Access Compliance Report

Public Rights-of-Way

Intersection ID: 44295	Main Street: PEACHWOOD_DR	Cross Street: ROCKWOOD_RD	Location: NW
ADA ID: FCF3403F1A93	Ramp Type: PerpDiag	Initial Pass/Fail: Pass	Overall Compliance: No
Severity Score: 30			
Codes/Mitigation Info/Possible Solution		Field Measurements/Component Compliance

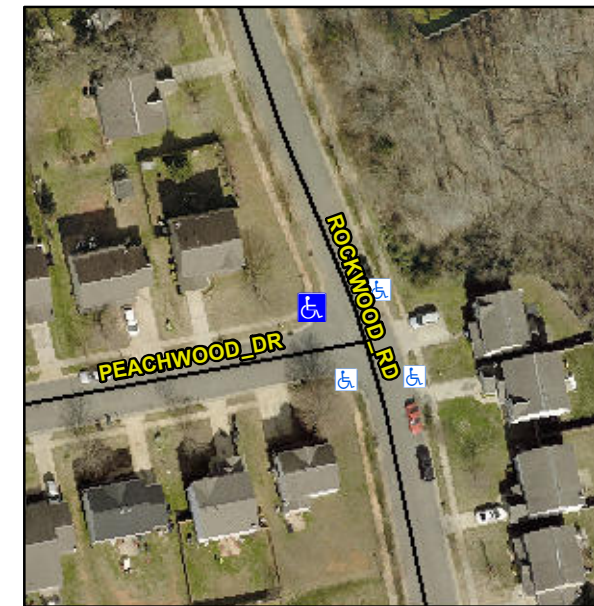
Not Found, R304.2.1, R304.2.2-Perp, R304.3.2-Para, R304.5.3, R305, R302.7.2, R304.5.4

Compliance	Description	Data	Compliance	Description	Data
N/A	Ramp Length (in)	47.0	Yes	Ramp Slope (%)	6.0
Yes	Ramp Width (in)	48.0	Yes	Ramp XSlope (%)	1.8
N/A	Flare Type LT	Sloped	N/A	Flare Type RT	N/A
N/A	Flare Slope LT (%)	4.4	Yes	Flare Slope RT (%)	6.5
N/A	Flare Traversable LT?	Yes	N/A	Flare Traversable RT?	Yes
No	Landing Length (in)	47.5	No	DWS Provided?	No
Yes	Landing Width (in)	48.0	N/A	DWS Contrast?	No
No	Landing Slope (%)	4.3	N/A	DWS Length (in)	N/A
No	Landing X Slope (%)	2.4	N/A	DWS Full Width?	No
N/A	Landing Curb? (Y/N)	No	N/A	DWS Offset (in)	N/A
N/A	Shared Landing?	No			
Yes	Gutter Ponding?	No	No	Gutter Slope (%)	11.6
No	Gutter Lip Ht (in)	1.0	Yes	Gutter X Slope (%)	0.7
N/A	Painted X Walk1?	No	N/A	Painted X Walk2?	No
	X Walk 1 Direction	To SE		X Walk 2 Direction	To E
N/A	X Walk 1 Width (in)	N/A	N/A	X Walk 2 Width (in)	N/A
	X Walk 1 Slope (%)	2.3		X Walk 2 Slope (%)	2.8
	X Walk 1 X Slope (%)	4.1		X Walk 2 X Slope (%)	1.6

Remove & Replace Curb Ramp With Two New Directional Ramps or Equivalent. Remove & Replace Gutter.
